TO: Mercedes-Benz Dealer Principals, General Managers, Sales Managers, Service Managers, Parts Managers	FROM: Gregory Gunther, Department Manager, Vehicle Compliance and Analysis, Engineering Services
RE: Recall Campaign Launch Notification 2018070015 Replace Oil Dipstick MY12-17 166 292 (GLE-Class, GLE-Coupe Class, GLS-Class)	DATE: August 17, 2018

Campaign No. 2018070015, August 2018

SUBJECT: **Models ML, GLE, GLE Coupe, GL, and GLS-Class vehicles (166, 292 platform)
Model Years 2012-2017
Replace Oil Dipstick of Active Curve System**

Figure 1

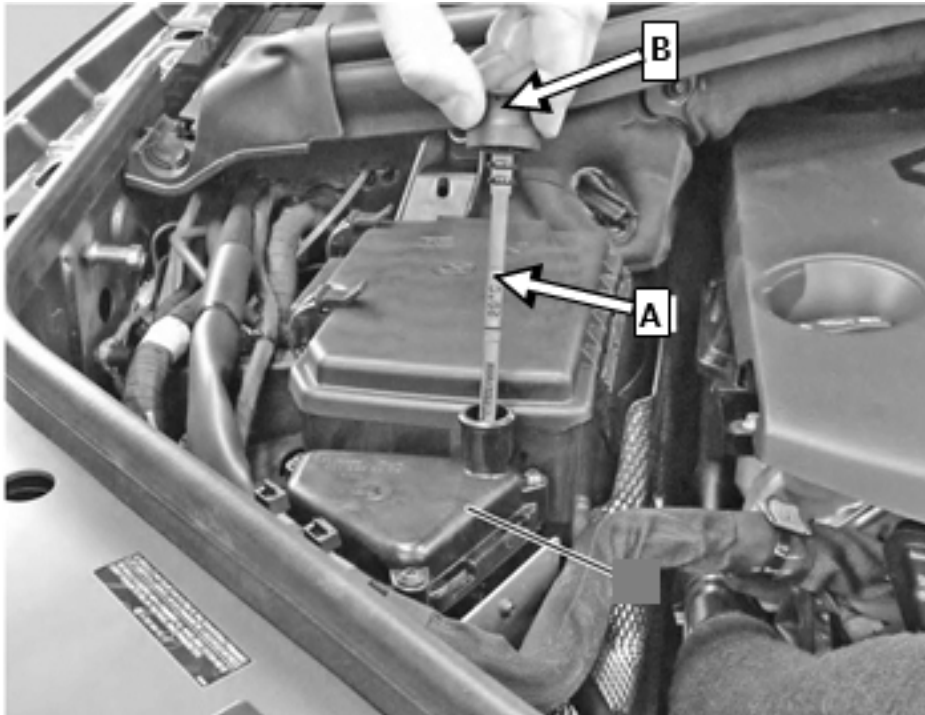
1. Replace oil dipstick (**A, Figure 1**) of ACS (ACTIVE CURVE SYSTEM) reservoir.
A new and optimized oil dipstick with filter is installed in the plug (**B, Figure 1**).
